RE: Crosby's Convenient Store
Route 242 & US Route 219
Ellicottville, NY 14731

SUBJ: Engineering Review of Site Plan Application

This is a response to the November 22, 2023, Barton & Loguidice, D.P.C. (B&L) Review letter.

ORIGINATED: 7-18-2023
DRAWN: VE
CHECK: JFG
JOB: D2300115
SHEET: C-6.0
STORMWATER POLLUTION PREVENTION PLAN

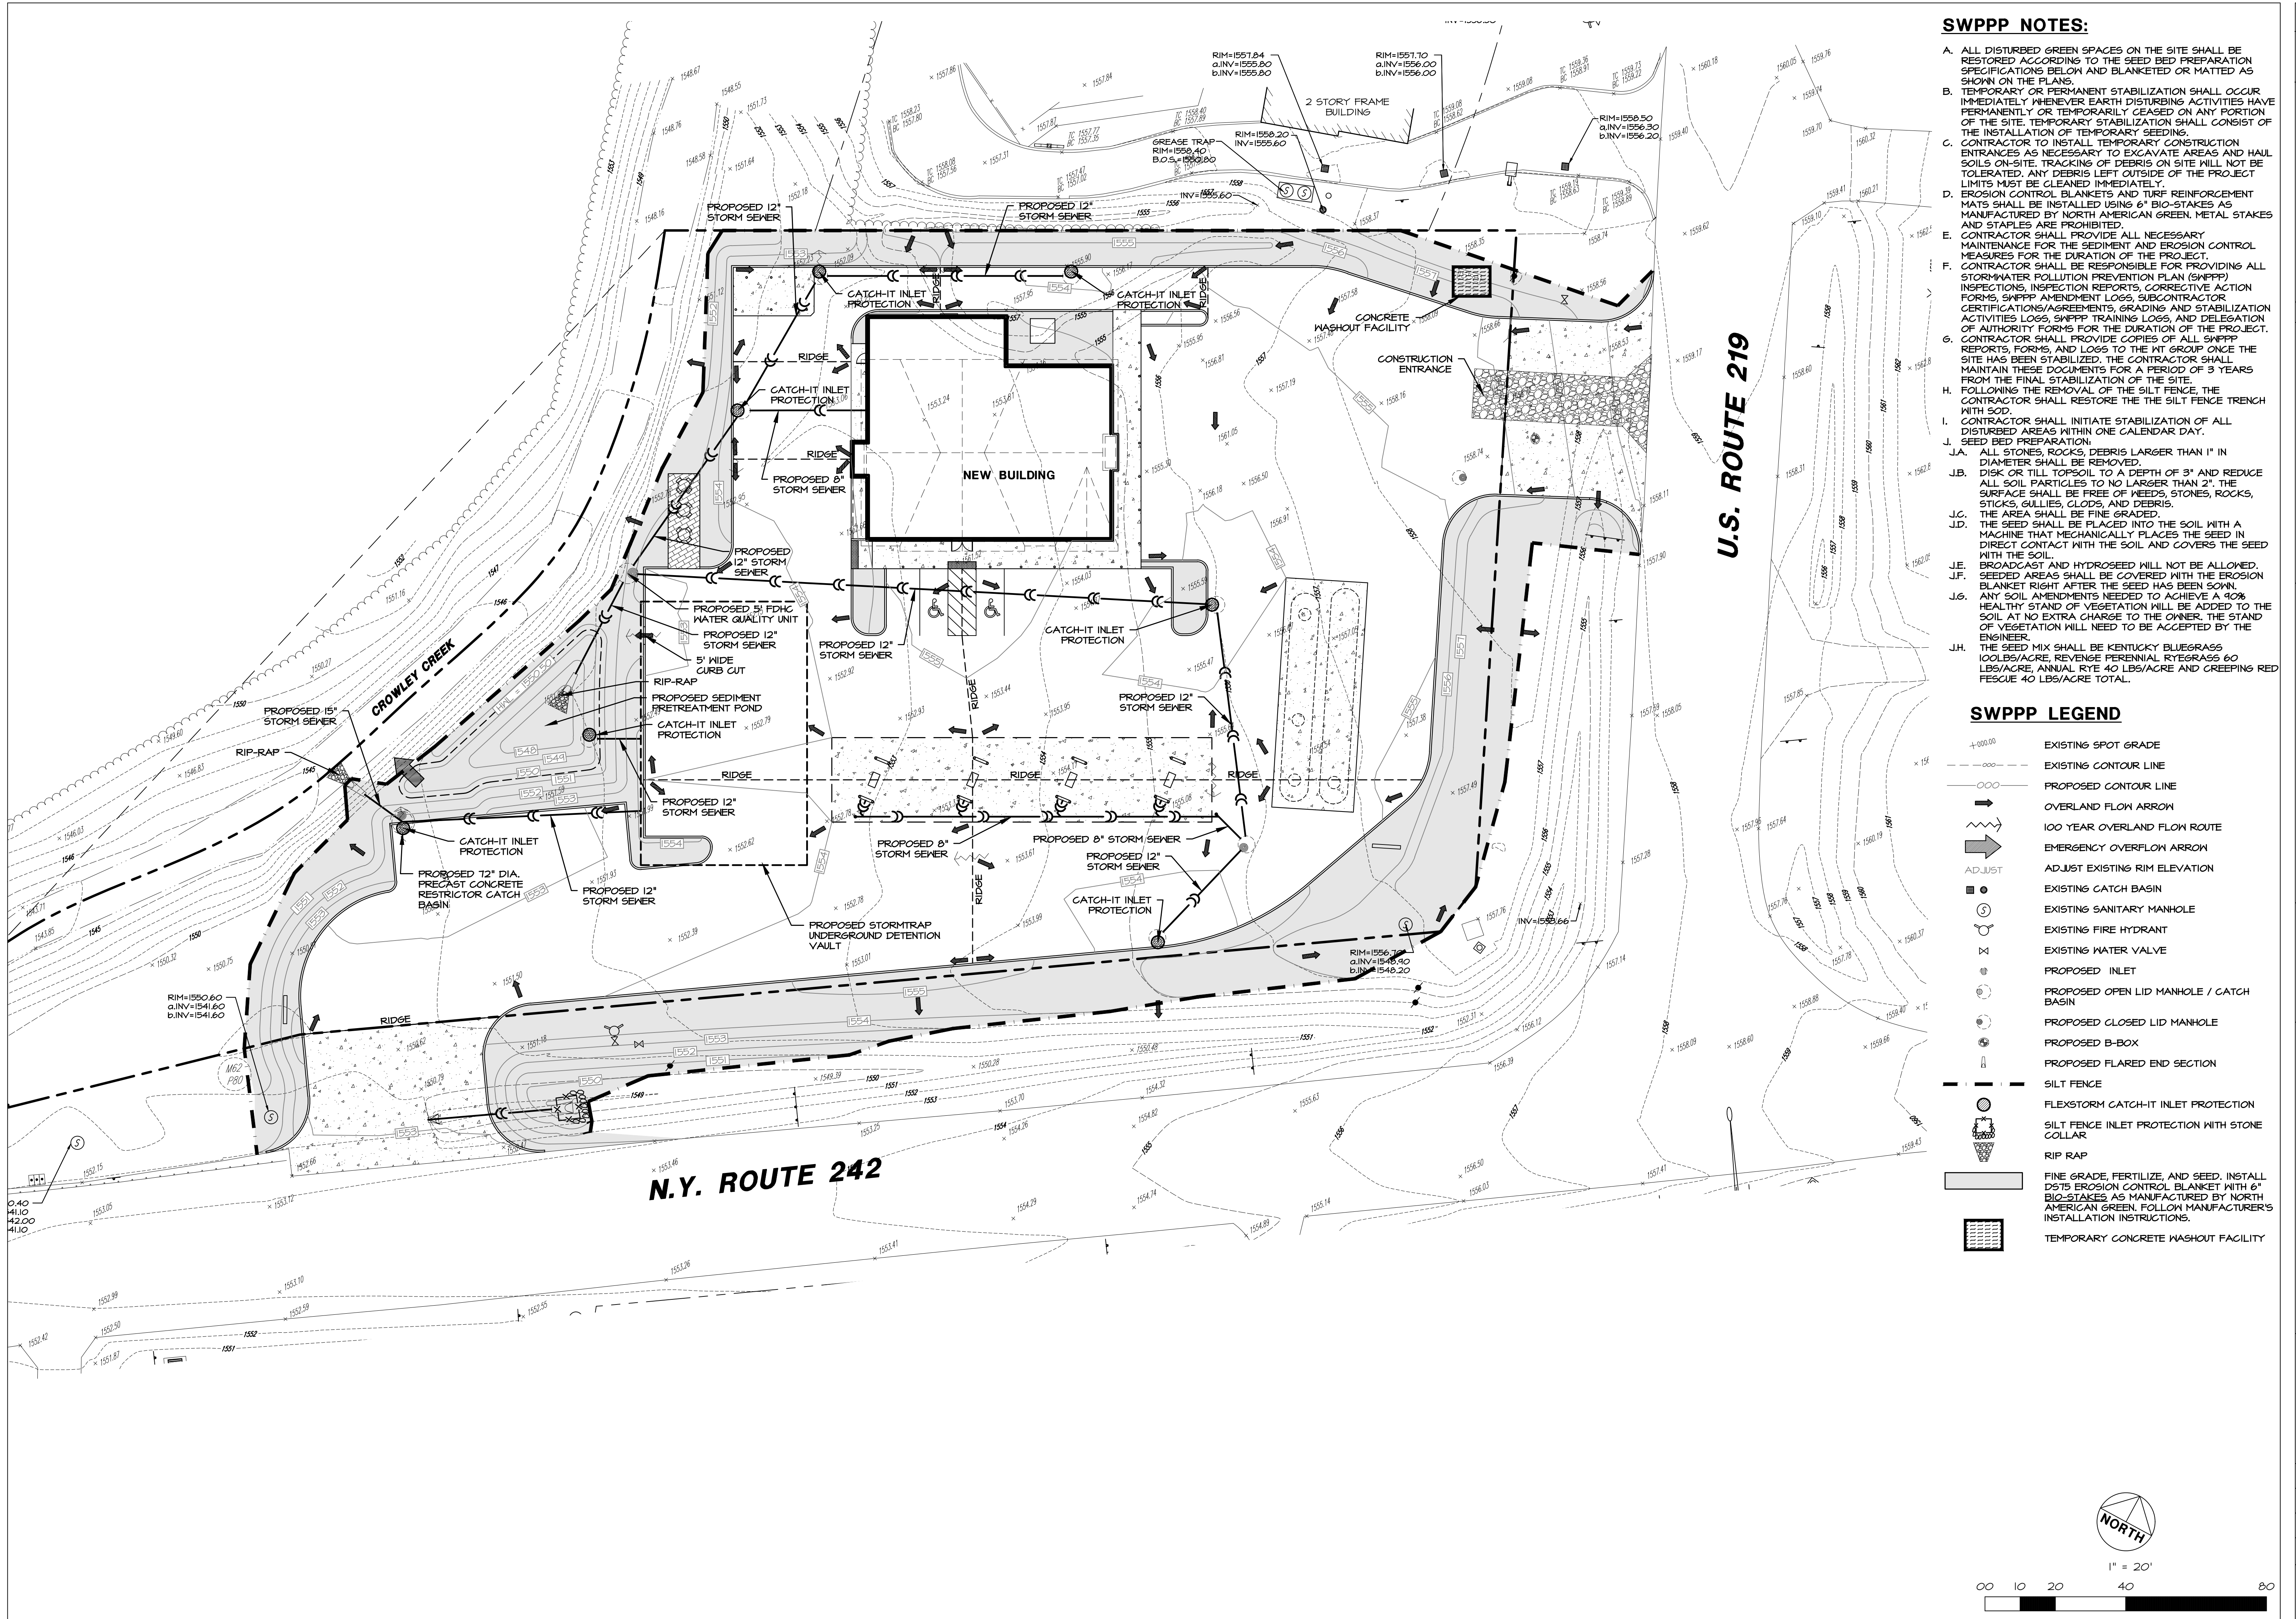
8. Please label all proposed pretreatment practices, storm water management practices, and subsurface pipes on the storm water pollution prevention plan sheet.

Response: These items have been labeled on the revised Stormwater Pollution Prevention Plan, sheet C-6.0.

Figure 5.30 Reinforced Silt Fence

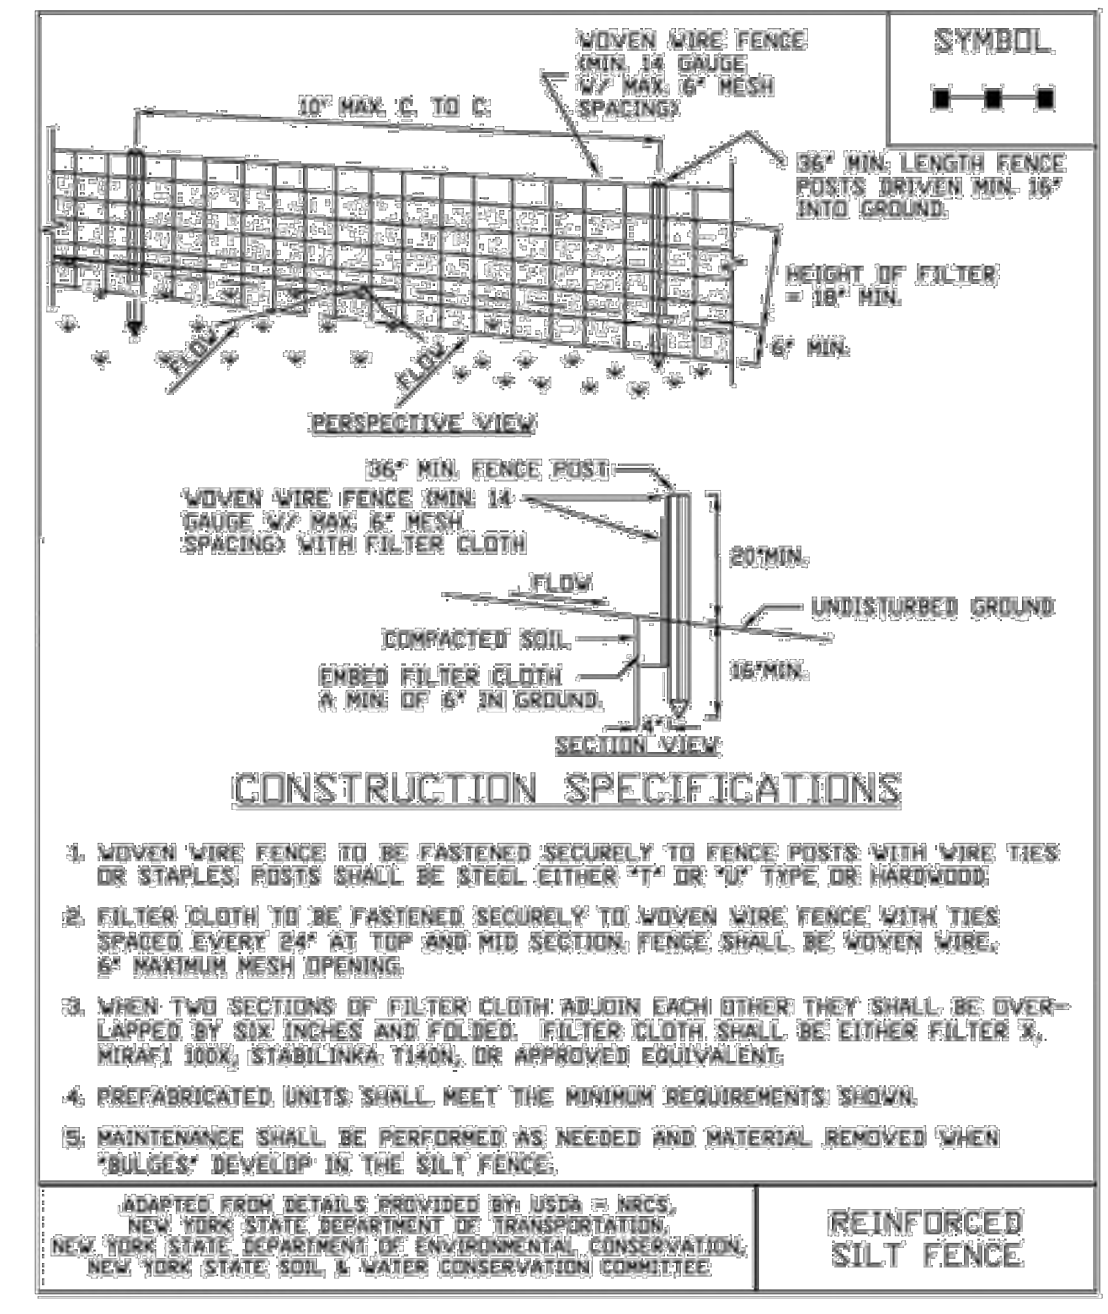
- 
9. There are several sections of silt fence shown proposed across contours. Silt fence should be installed along contours per NYS Standards and Specifications for Erosion and Sediment Control (November 2016). Alternative erosion and sediment control practice(s) may need to be utilized in some areas.

Response: The originally proposed silt fence detail has been replaced with the NYS Standard reinforced silt fence detail as shown on the Stormwater Pollution Prevention Details, Sheet C-6.1.

Lighting Proposal LD-158657-2

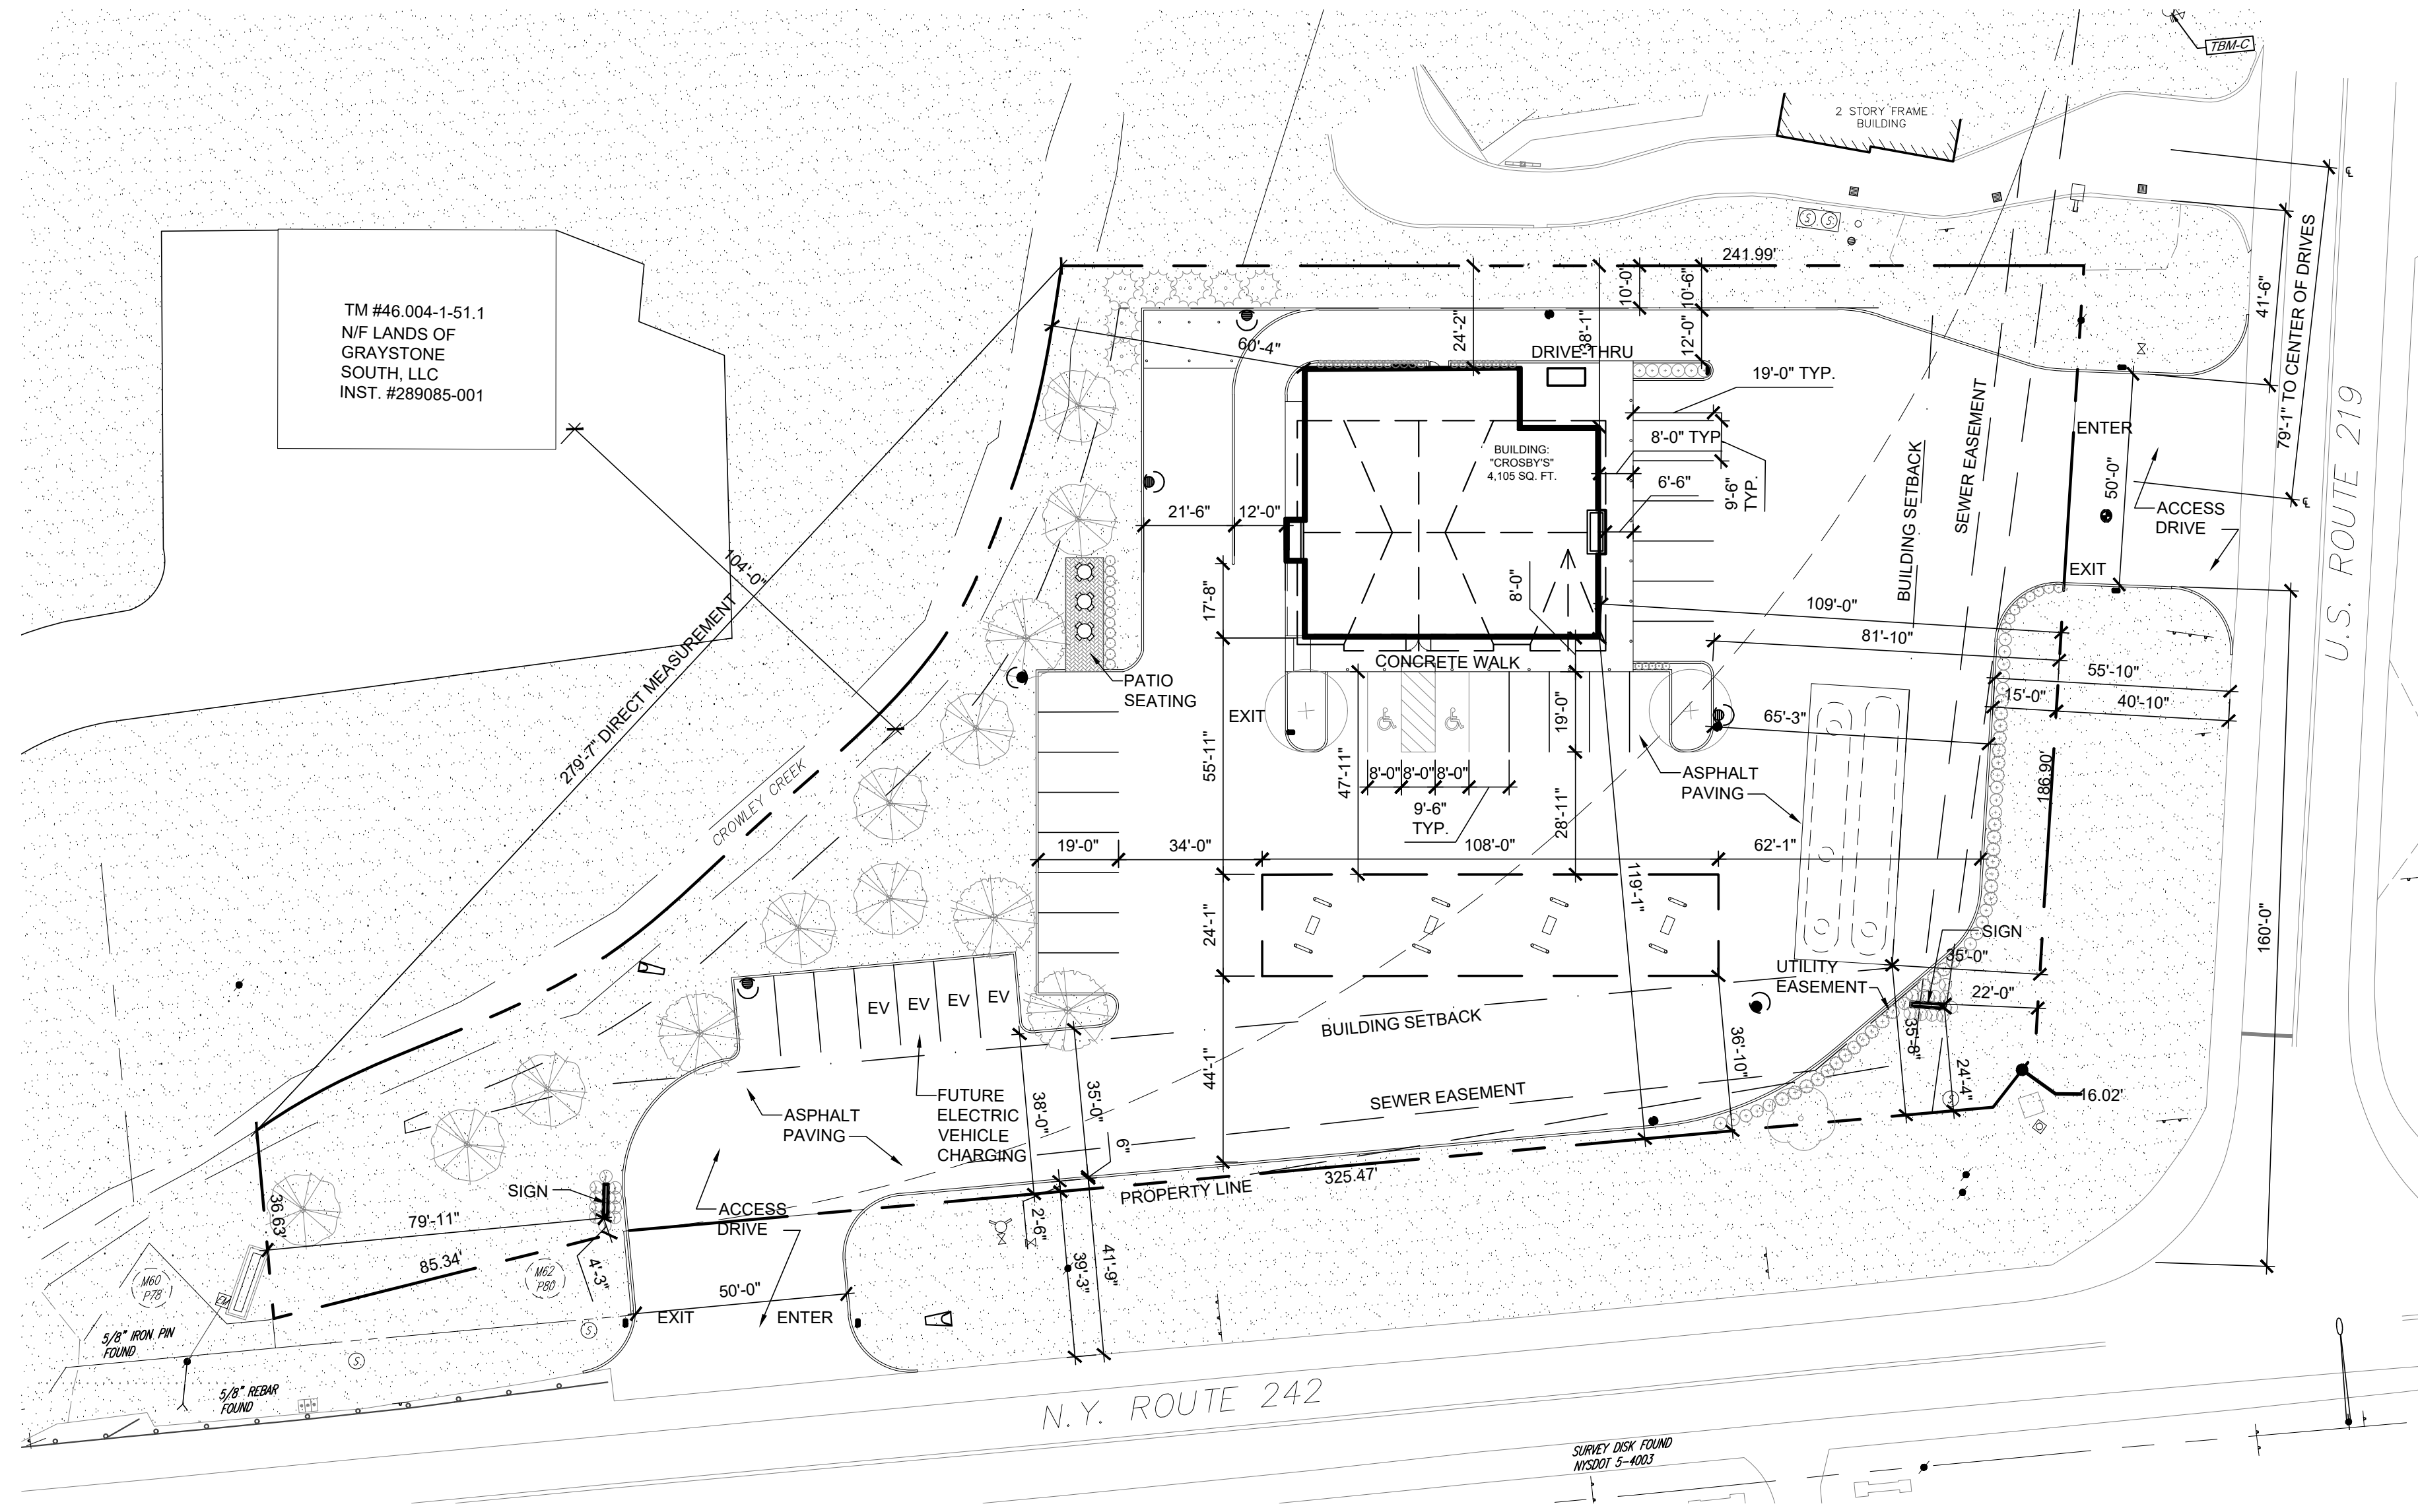
10. There are areas along the northeastern site boundary where illumination levels are proposed above 0.1 foot-candles. Per Town Zoning Law 12.2.C.1.h, the maximum light level allowed at a point within five (5) feet of the adjacent property is 0.1 foot-candles.

Response: Updated Information has been resubmitted.
